STAFF RECOMMENDATION

NCPC File No. 6759

WALTER REED NATIONAL MILITARY MEDICAL CENTER MEDICAL FACILITY ADDITIONS – BUILDINGS A AND B

8901 Rockville Pike
Montgomery County, Bethesda, Maryland

WEST ELEVATIONS – BUILDINGS A and B

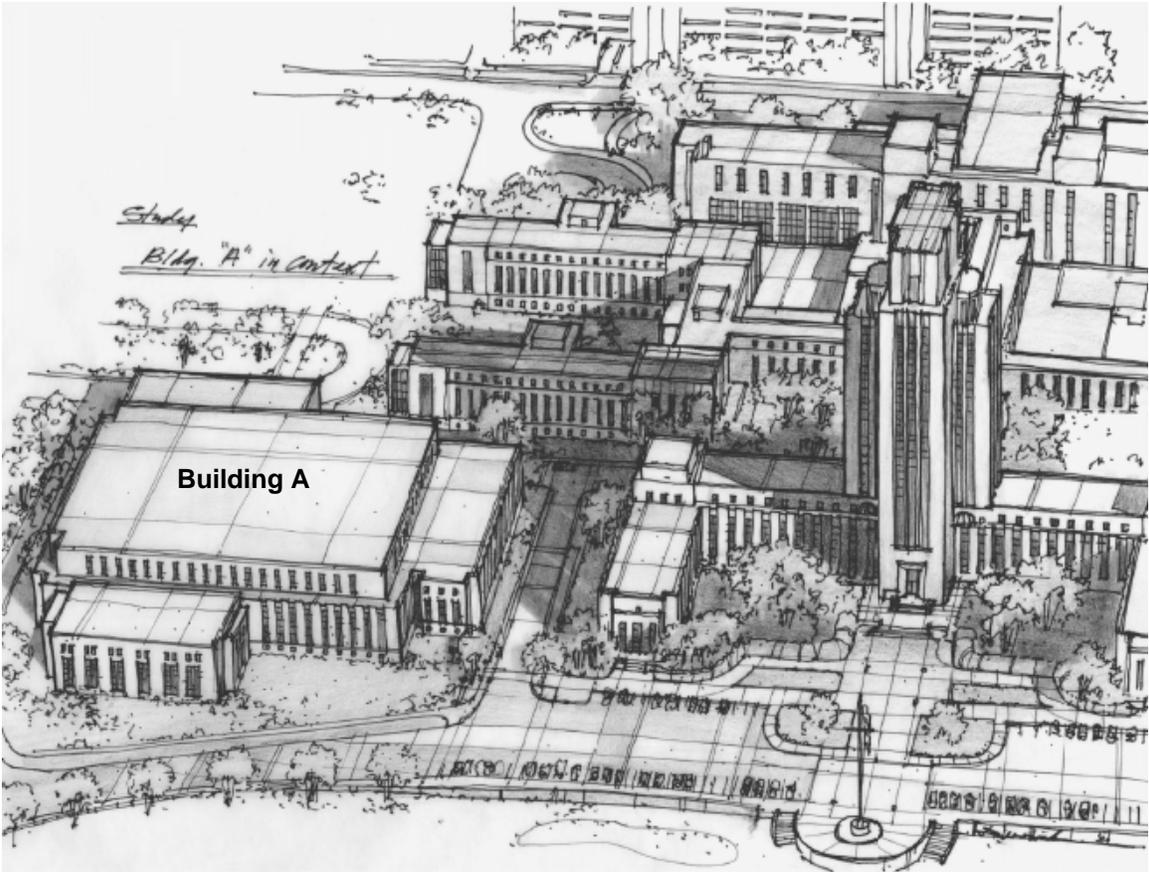
Staff finds that the proposed building additions meet the design parameters that were formulated during consultation with NCPC and MD-SHPO staffs with regard to footprint, building frontage/setbacks, symmetry, building heights, and preservation of view sheds and historic landscapes. Additionally the scale, massing, and material selection for the new buildings are well developed and appropriate additions to the WRNMMC medical facility; the applicant and design team are to be commended for their ongoing consultation and responsiveness to NCPC and MD-SHPO staffs, including site and building development that is well developed, sophisticated, and complementary to the appearance of historic Building One, while enhancing the overall image of the Medical Center.

In response to the Commission Action at the Concept design review, the applicant has revised the elevations to include more compatible fenestration patterns, and has provided additional information with regard to the building's overall size and height, landscaping, and proposed finish materials. The building will not have exterior accent lighting and will not detract from the nighttime appearance of Building One.
